Burlington Design Advisory Board

DESIGN ADVISORY BOARD Tuesday May 11, 2021 3:00 PM REMOTE MEETING

To: The Design Advisory Board
From: Mary O'Neil, AICP, Principal Planner
RE: ZP21-0799CA, 157-159 South Champlain Street
Date: May 11, 2021

To: The Design Advisory Board
From: Ryan Morrison, Associate Planner
RE: ZP21-0963SP, 278 Main Street (Sketch Plan)
Date: May 11, 2021

East Elevation

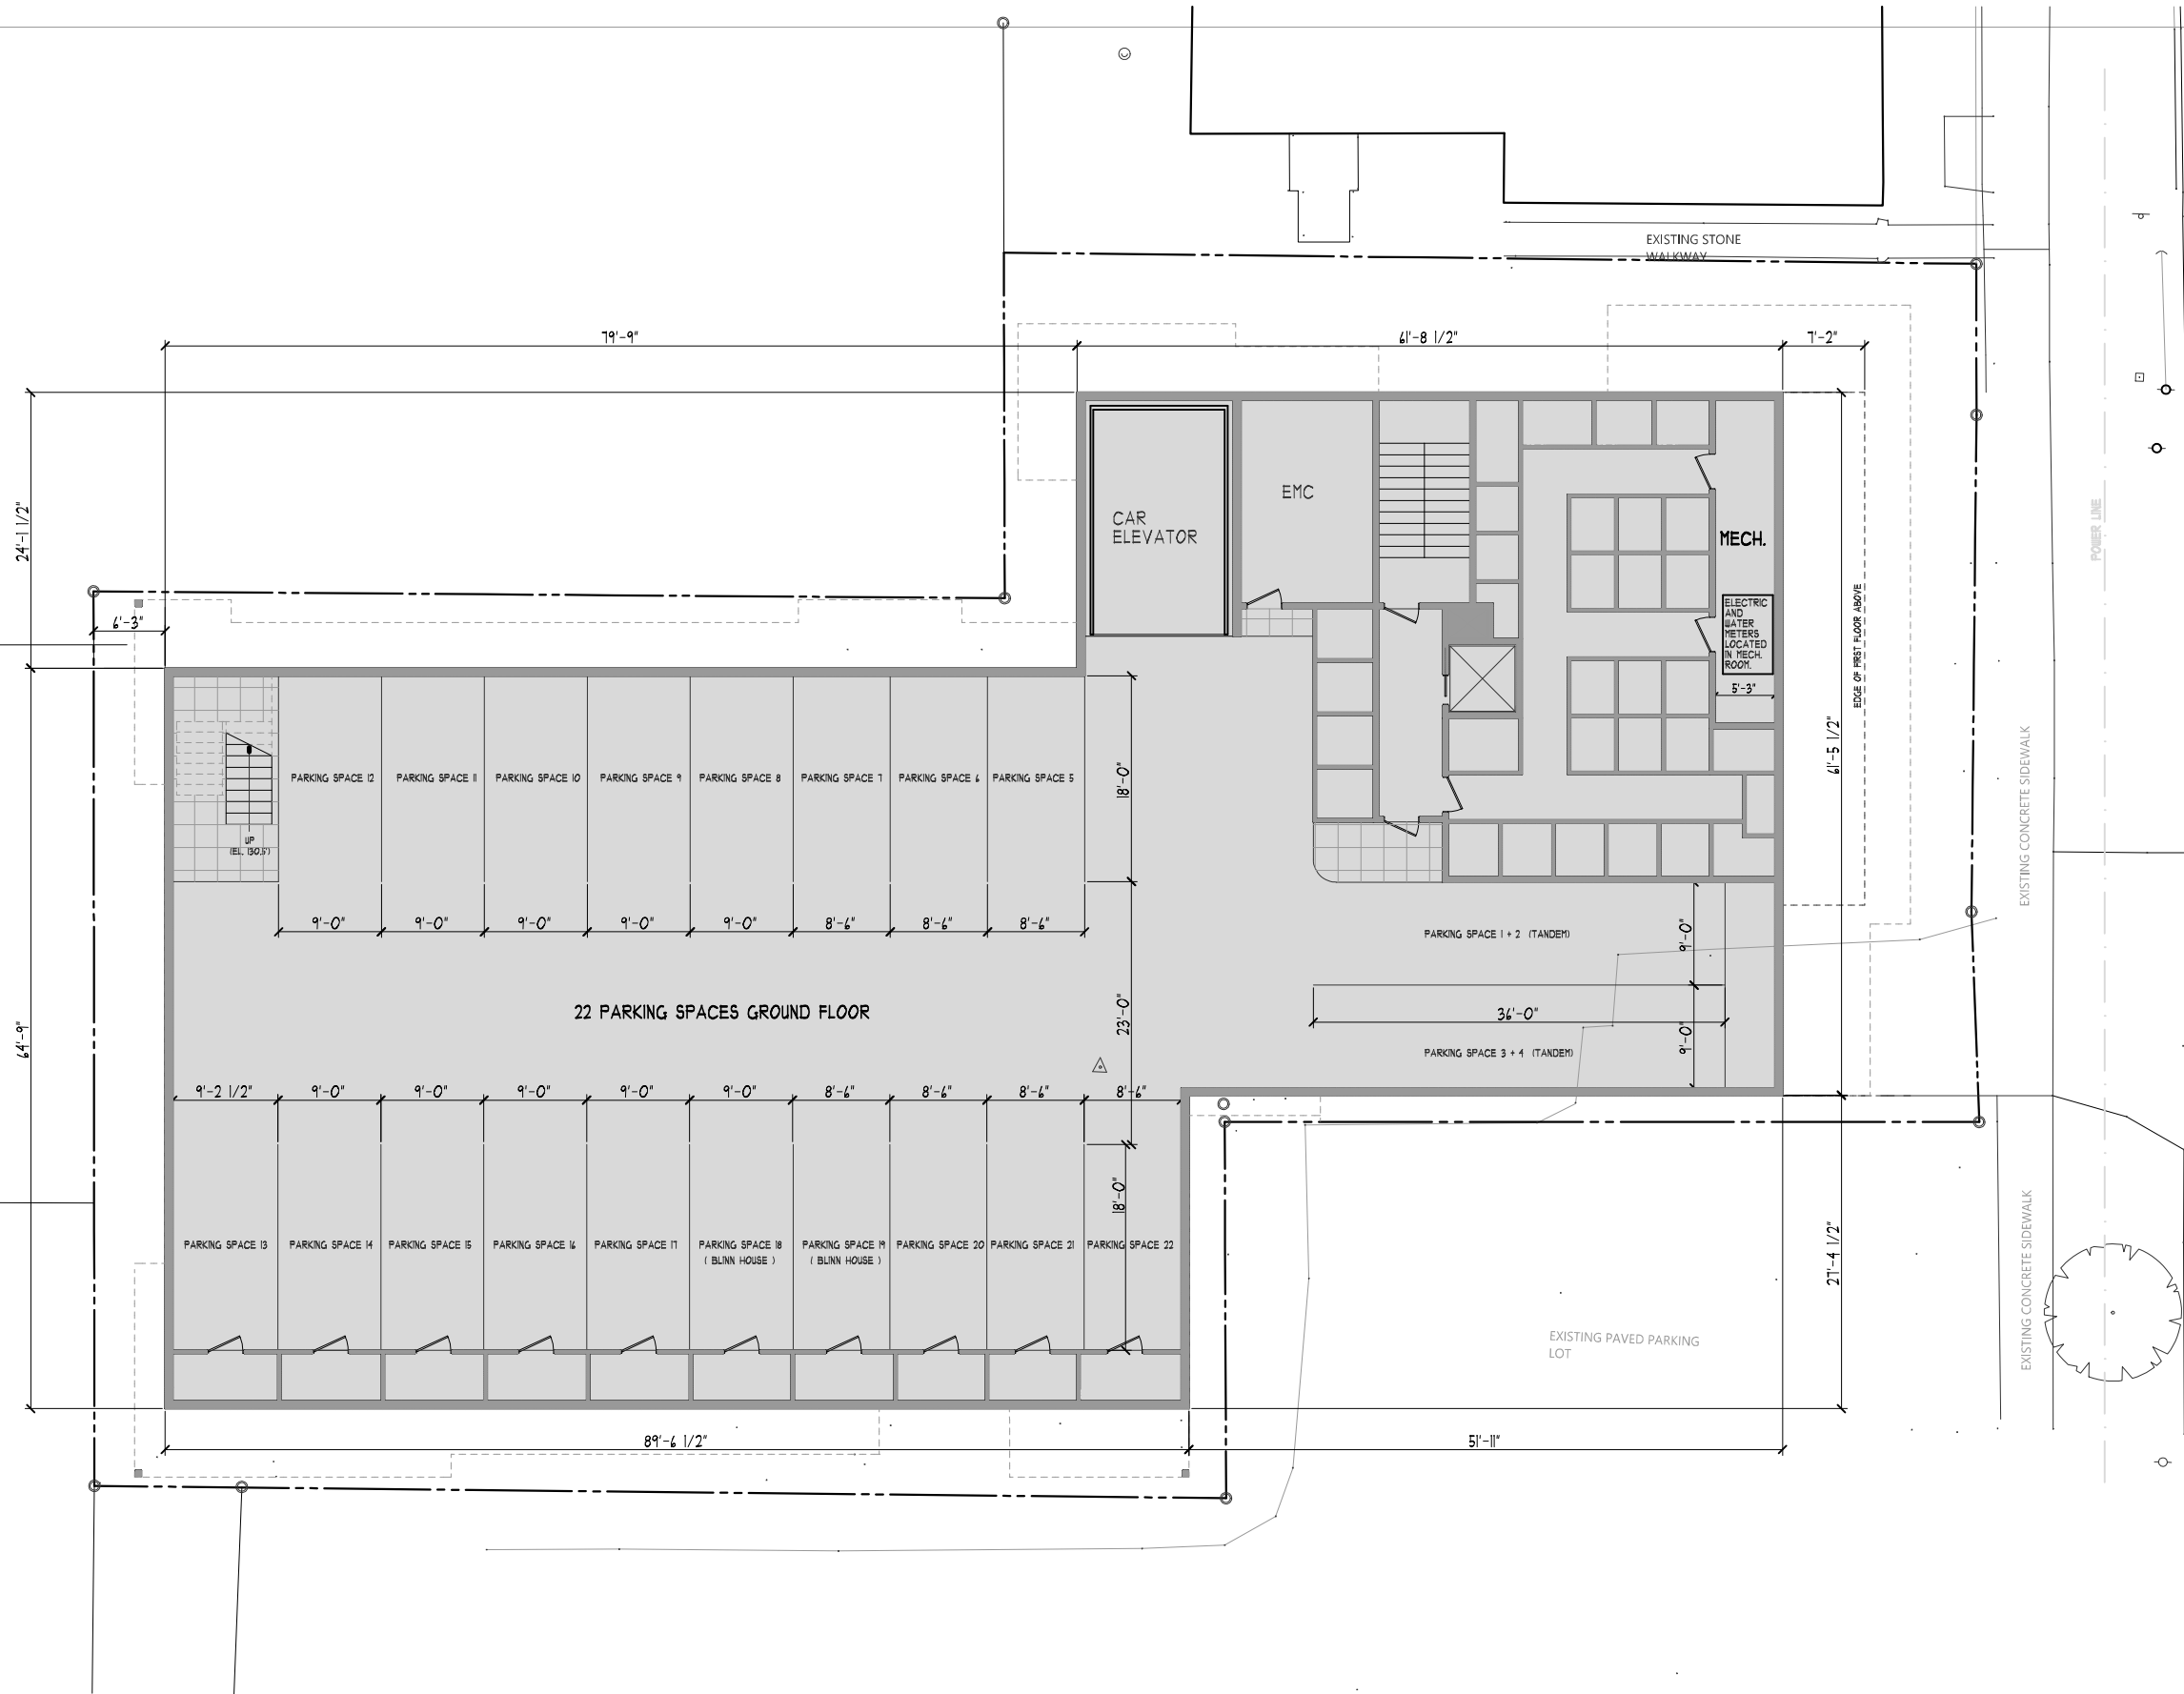
The proposed building height is 57', is within the DRB allowance (55') with

consideration of the additional 5% (2.75') allowable per 5.2.6 (b). No additional stories are proposed above the 5 story limitation with DRB approval.

From the applicant: To mitigate the impact of the requested additional 2'-0" of building height beyond the allowed 55' the primary façade along South Champlain Street is broken up into (3) bays with the middle bay broken up again into (3) smaller bays or vertically oriented segments. The north and south bays are stepped back 11'-7". The thin projecting terraces, horizontally delineated in these bays (the north terraces projecting past the north façade) further erode the northeast and southeast corners of the building reducing the perceived mass and height. The middle bay maintains vertically oriented proportions by cladding the center of the middle bay with a light granite flanked by north and south bays of dark brick. Visual interest is created by the contrasting materials and the relief provided by the detailing of the material and the projecting sills and lintels. The higher percentage of windows (void), the larger size of the windows and the stepped back first floor further help to reduce the perceived height of the building.

1 SITE PLAN

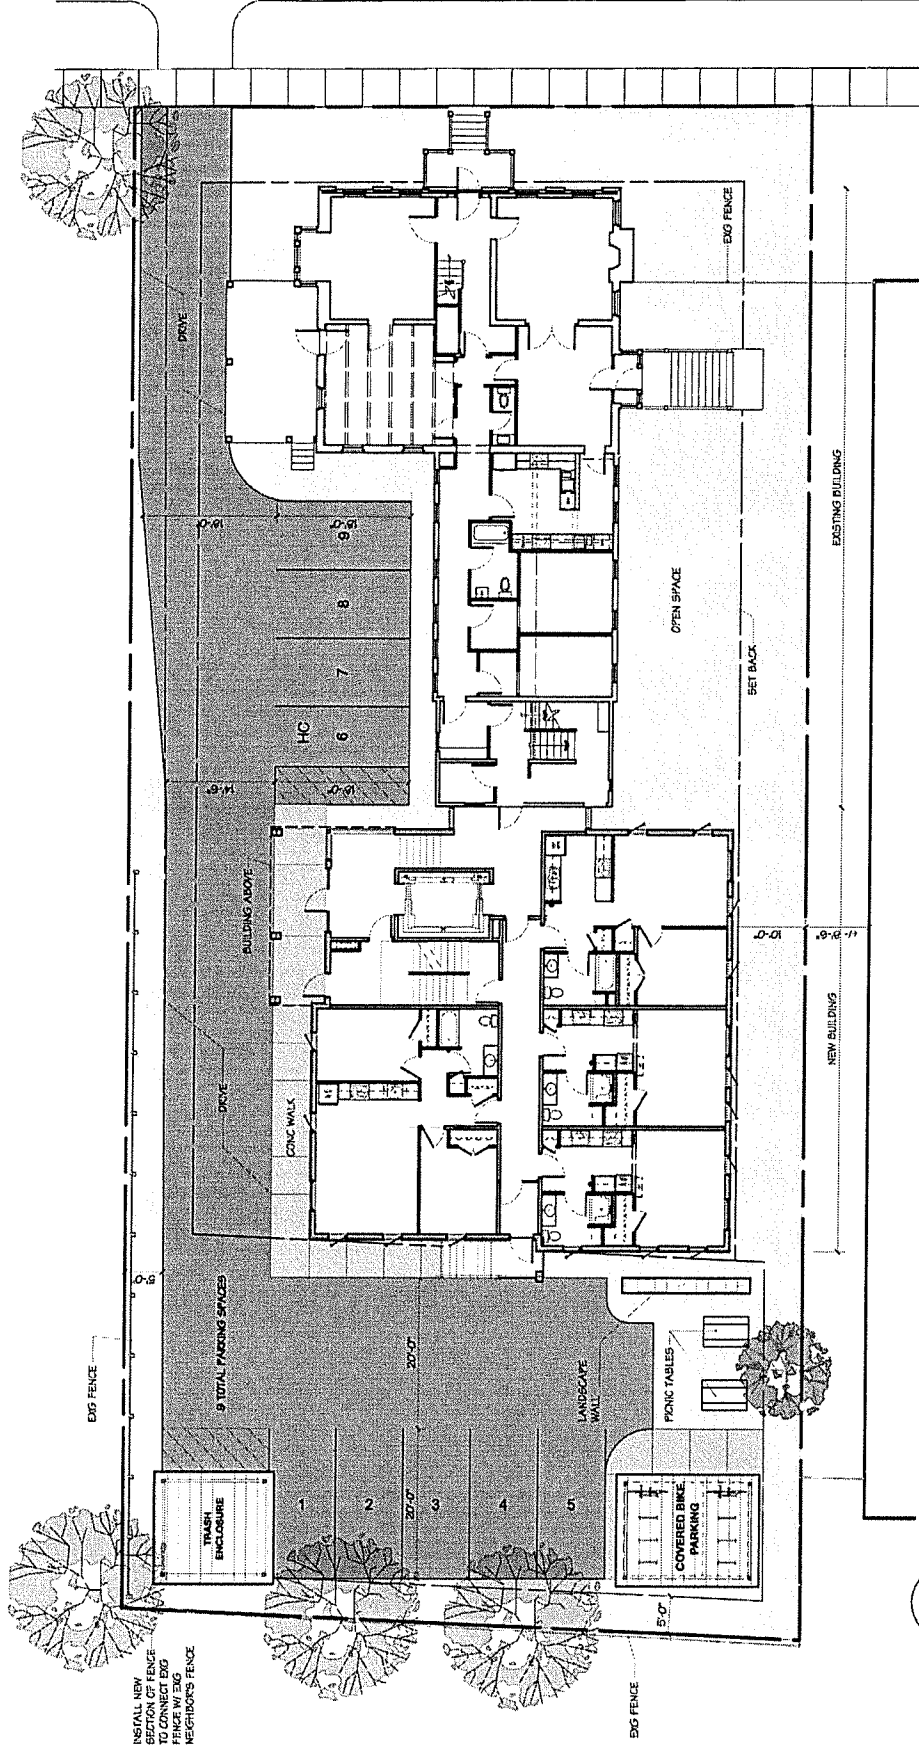
The existing access off Main Street will continue to provide access to the property. The driveway will continue along the east property line to provide vehicular access to both parking areas and the trash enclosure.

Pedestrian access to the existing building will remain as existing. There is a front entrance with a direct walkway to the Main Street sidewalk. There are no walkways identified on the plan that will allow for direct, unobstructed outdoor pedestrian access to the rear addition. It is conceivable that pedestrian access to the rear addition could avoid walking along the driveway by going through the existing building.

Aside from direct pedestrian access from the sidewalk, the plans do show a walkway along the east wall of the existing building's rear section, as well as along the east and north walls of the proposed addition.

Circulation within the site is clear: one driveway along the east property line to provide access to the two separate parking areas. The property is within the Multimodal Mixed-Use Parking District, which eliminates any parking requirements. The proposal includes, however, two separate parking areas for a total of 9 onsite parking spaces. As required by Sec. 8.1.16 *Transportation Management Plan*, the applicant will be required to provide a Transportation Demand Management (TDM) plan for review since the proposal includes more than 10 new dwelling units, and possibly more than 15,000 sf of new gross floor area. Each of the elements identified under this section will need to be addressed in the plan.

The site plan identifies open space along the west side. It is assumed that this area will be open to use for tenants of the property. To the rear of the new addition, picnic tables are identified for tenant use as well.

The plans show a trash enclosure in the northeast corner of the lot. No other references are made for utilities, mailboxes, etc. The applicant will need to revise the plans to include utilities and amenities such as electric meters, mechanical units, infrastructure connections (water, sewer, gas) mailboxes, etc. If existing utilities/infrastructure will be used, please provide documentation as such. Additionally, a letter from the Department of Public Works will be required to confirm that there is adequate water and sewer capacity for the proposal. A state stormwater permit will also be required.
